Enclosure 2
Westinghouse APP-GW-GLR-607, Revision 1
(NON-PROPRIETARY VERSION)
(61 pages including cover page)

Changes to Passive Core Cooling System Condensate Return

Figure 3: Simplified Downspout Configuration

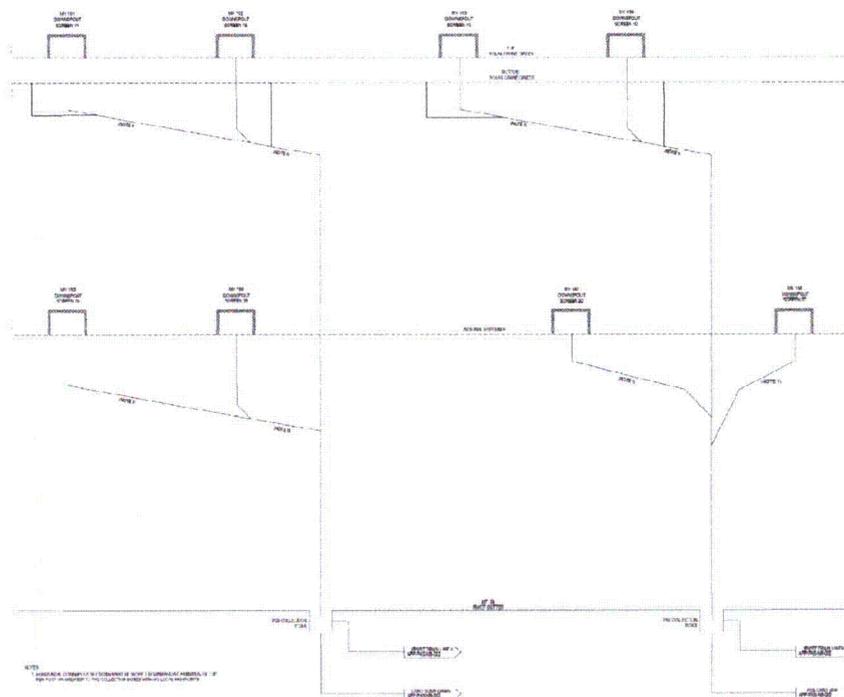
A downspout piping network would be added to collect and transport condensation from the PCG and stiffener to the IRWST gutter collection boxes. The downspouts would consist of two downspout branches, each with two connections to the top of the PCG, two connections to the bottom of the PCG and two connections to the internal stiffener. Figure 3 illustrates the two downspout branches incorporated into the PXS system design. In each branch, the four connections from the polar crane girder would join together into a common header which extends below the internal stiffener. The two connections from the stiffener would join together into a common line, which would connect to the header below the stiffener. The header would be routed to one of the two PXS collection boxes at either side of the IRWST. The downspouts would be situated with approximate symmetry around the circumference of containment. The common header for each branch would pass through the internal stiffener. These pass-through locations would include penetration sleeves to allow sufficient depth for collection at the stiffener downspout inlets.

Figure 8: Personnel Airlock Gutter Modification Schematic

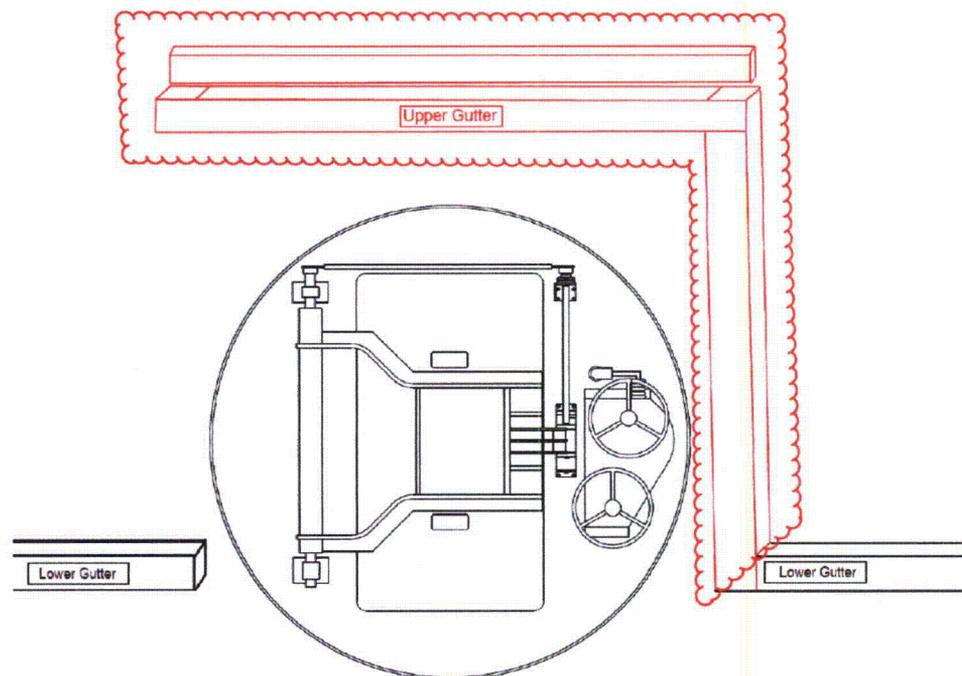
The original IRWST gutter was routed to the edges of the Upper Personnel Airlock and Upper Equipment hatch. [

]a,c The IRWST gutter will be modified to have an upper gutter above each of the hatches that connects with the existing gutter. The extended gutter is of the same size as the sections which currently interface with the sides of the hatches. The gutter is sloped the same as the existing portions of the gutter. The extended portion of the gutter above the Upper Personnel Airlock is routed to interface with the lower portion of the gutter. Figure 8 shows a schematic of the proposed modification to the IRWST gutter to above the Upper Personnel Airlock. The Upper Equipment Hatch is similarly treated.

Figure 3.8.2-1 (Sheet 3 of 3)

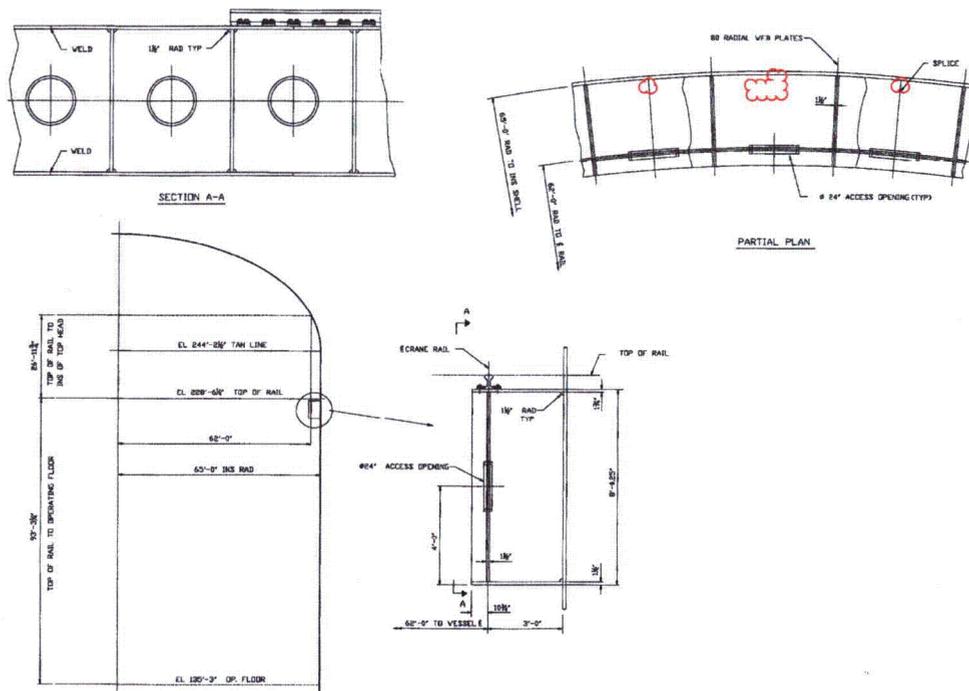
Pictorial detail of the Polar Crane Girder is shown in DCD Chapter 3. Figure 3.8.2-1 (Sheet 3 of 3) shows the fabrication holes in the top right figure. As the fabrication holes in the PCG would be blocked in the modified configuration, this detail would be removed from this figure. The changes are shown in Appendix B.

Passive Core Cooling System
Piping and Instrumentation Diagram (Sheet 1 of 3)

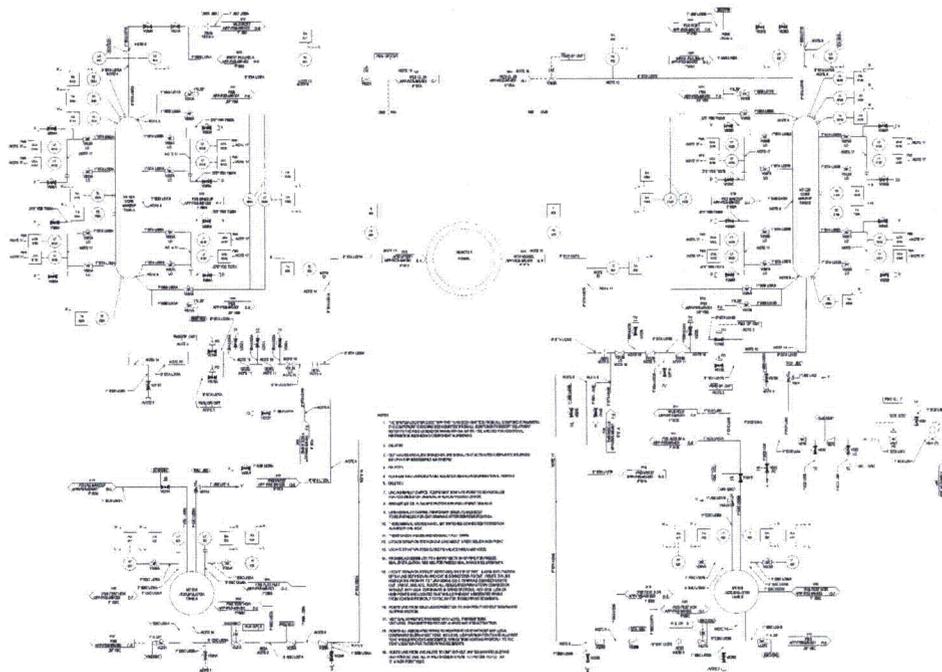
- Subsection 6.3.2.2.7.2 would be updated to clarify the condensate return gutter arrangement related to LOCA operation.
- Figure 6.3-1 will be relabeled Figure 6.3-1 (Sheet 1 of 3). This editorial change is the only change made to this figure. No technical changes are made.

Passive Core Cooling System
Piping and Instrumentation Diagram (Sheet 2 of 3)

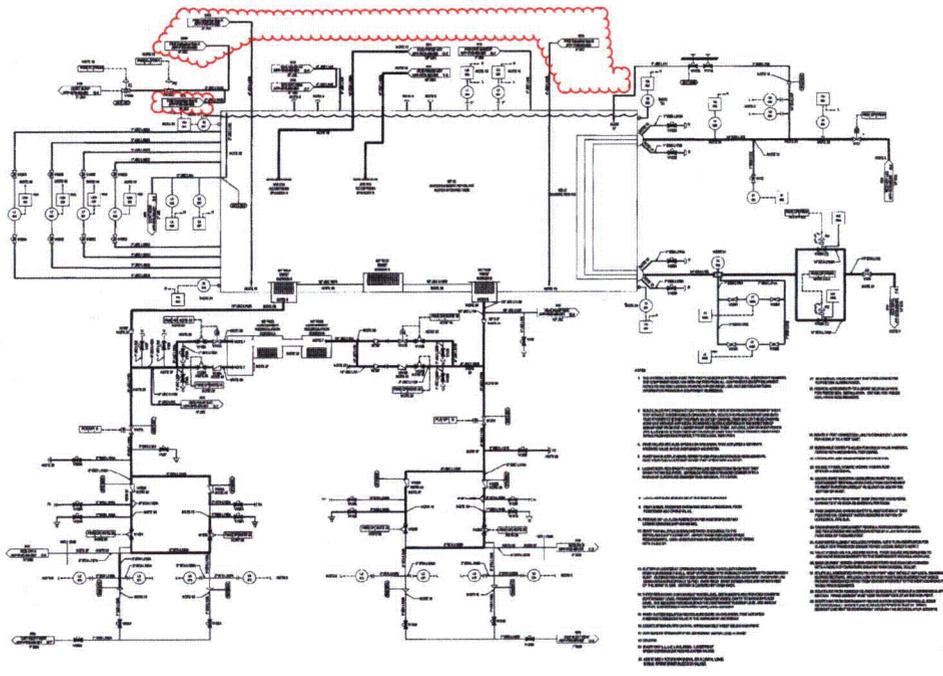
- Figure 6.3-2 will be relabeled Figure 6.3-1 (Sheet 2 of 3). On relabeled Sheet 2, the IRWST gutter has been relocated to a new sheet 3 of the PXS P&IDs. Sheet 2 has been modified to include continuation flags for condensate returning to the IRWST originating

- from PXS Collection Boxes A and B in the IRWST gutter.
- Figure 6.3-1 (Sheet 3 of 3) is a new P&ID sheet and will be added to the licensing basis. This new figure shows the relocated IRWST gutter and the screens and piping comprising the PXS downspouts originating from the Polar Crane Girder and internal stiffener.
 - Figure 6.3-2 will not be used.
 - The Chapter 6 List of Figures will be updated to reflect the PXS figure relabeling and the additional PXS P&ID sheet.
 - Reference to Figure 6.3-2 in subsection 6.3.2.1 is changed for consistency.

(Renumbered as Figure 6.3-1, Sheet 2)

Figure 19E.4.10-1

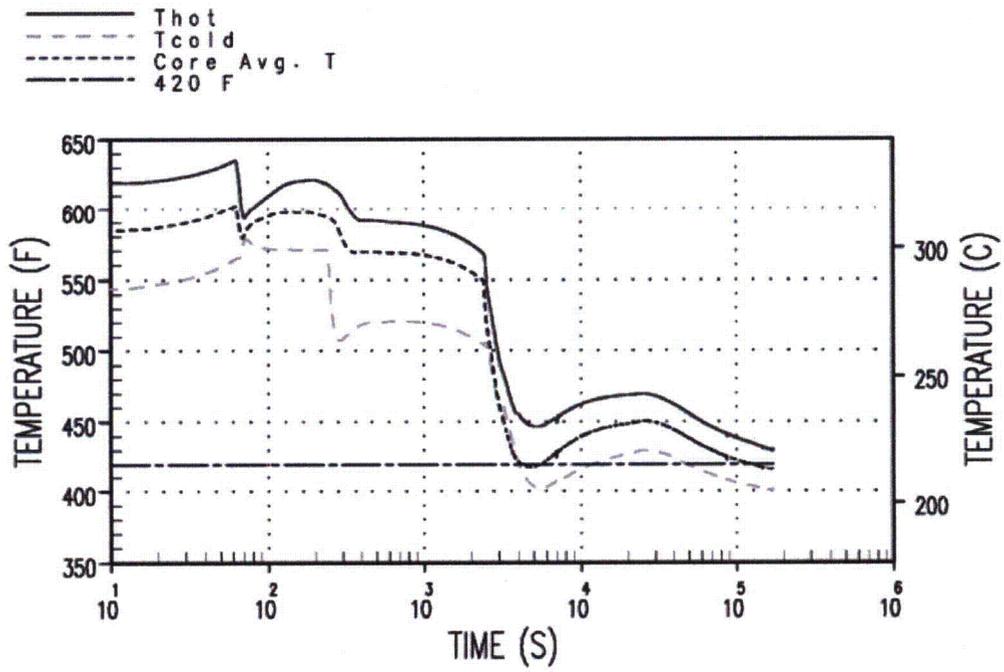
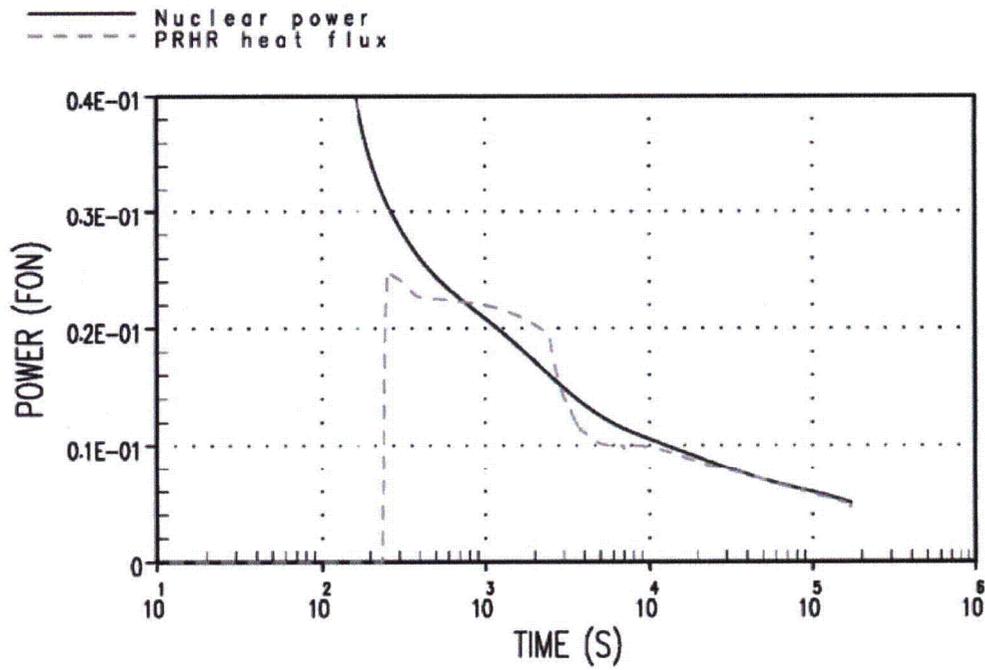
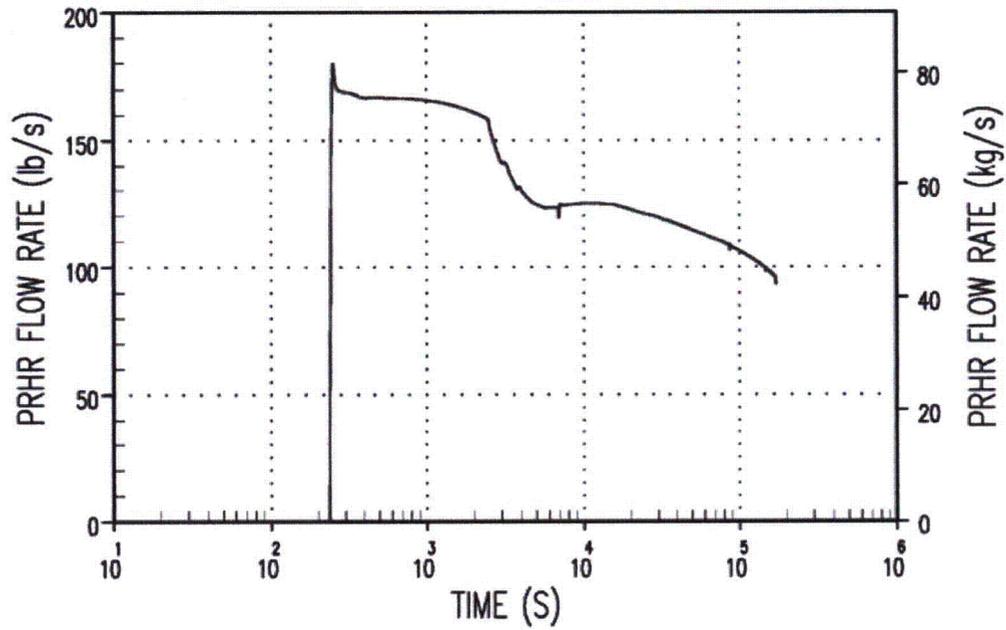
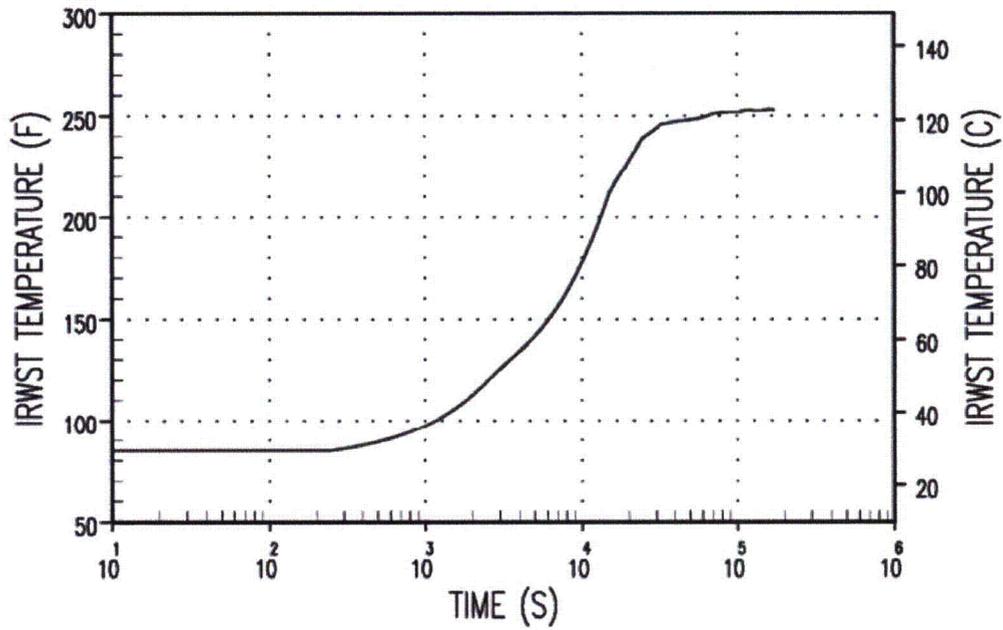
Changes to Chapter 19 would include changes to subsection 19E.4.10.2, Shutdown Temperature Evaluation, to describe the analysis methodology for a non-LOCA shutdown event, the time for the cold leg and core average temperatures to reach the specified safe, stable condition after shutdown following a loss of ac power event, and updates to corresponding tables and figures, which further detail the sequence of events. The changes to Chapter 19 are shown in Appendix B.

Once actuated, at about 2,400 seconds, the CMTs operate in recirculation mode, injecting cold boric acid water into the RCS. In the first part of their operation, due to the cold flow rate, the CMTs operate in conjunction with the PRHR to reduce RCS temperature. Due to the primary system cooldown, the PRHR heat transfer capability drops below the decay heat and the RCS cooldown is essentially driven by the CMT cold injection flow. However, at about 5,000 seconds, the CMT cooling effect decreases and the RCS starts heating up again (Figure 19.E.4.10-1). The RCS temperature increases until the PRHR HX can match decay heat. At about 34,500 seconds, the PRHR heat transfer matches decay heat and it continues to operate to reduce the RCS temperature to below 420°F within 36 hours. As seen from Figure 19E.4.10-1, the cold leg temperature in the loop with the PRHR is reduced to 420°F within 48,600 seconds, while the core average temperature reaches 420°F within 124,400 seconds (approximately 34.6 hours).
